8568B-04A

S E R V I C E N O T E

HP 8567A Spectrum Analyzer
 HP 8568A Spectrum Analyzer
 HP 8568B Spectrum Analyzer

Frequency Spur Correction

Figure 1. Component Locations

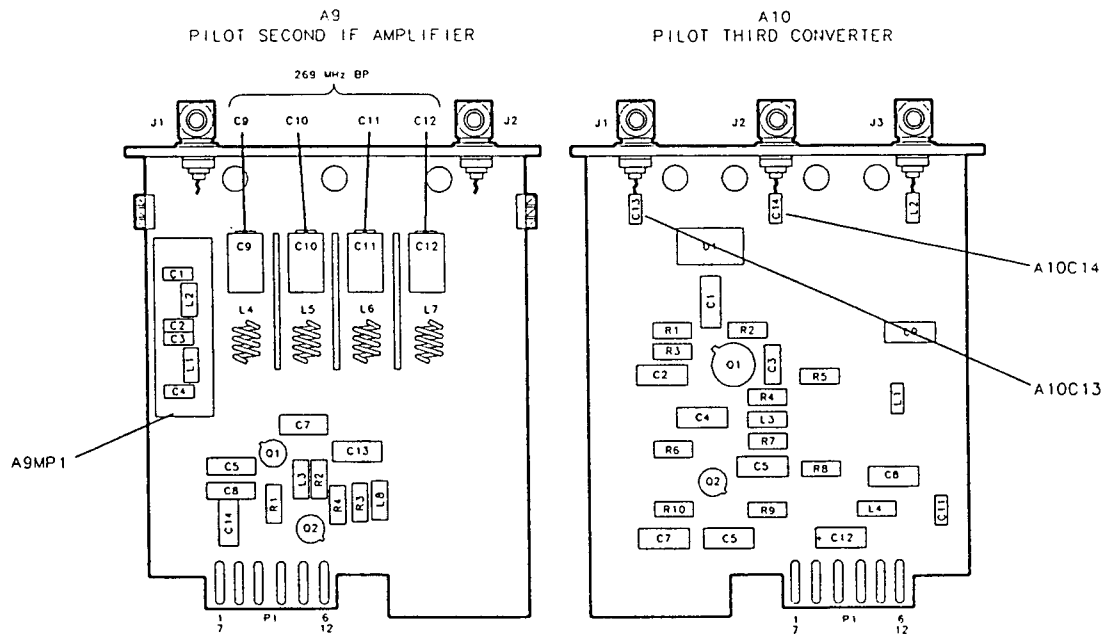
Signals from the A23 RF Converter Assembly feed through the A9 Pilot Second IF Amplifier Assembly and mix with the A10 Pilot Third Converter Assembly. This prevents the spectrum analyzer's meeting specifications for spurious responses (75 dB below -40 dBm total signal power at the input mixer).

$(5 + 20 \times N)$ MHz, and $(12 + 20 \times N)$ MHz, where N equals the harmonic number of the 20 MHz Comb Generator

1. Separate the two instrument sections and set the IF-Display section aside.
2. Remove the two rear feet and the bottom cover from the RF section.
3. Using a #1 pozidrive screwdriver, remove the 4-40 screws from around the A9 Pilot Second IF Amplifier and the A10 Pilot Third Converter Assemblies. Remove these assemblies from the instrument and place them on a static-free work surface.
4. Solder A9MP1 (HP part number 7100-1304) to the ground plane as shown in Figure 1.

The shield is installed over the A9 lowpass filter. First remove the upright shield between this filter and A9C9 and A9L4, if present.

5. Install the two 10 pF capacitors on the A10 assembly. See Figure 2.
 - a. Solder one lead of A10C13 to A10J1 and the other lead to the ground plane.
 - b. Solder one lead of A10C14 to A10J2 and the other lead to the ground plane.
6. Install the A9 and A10 assemblies into the RF section.
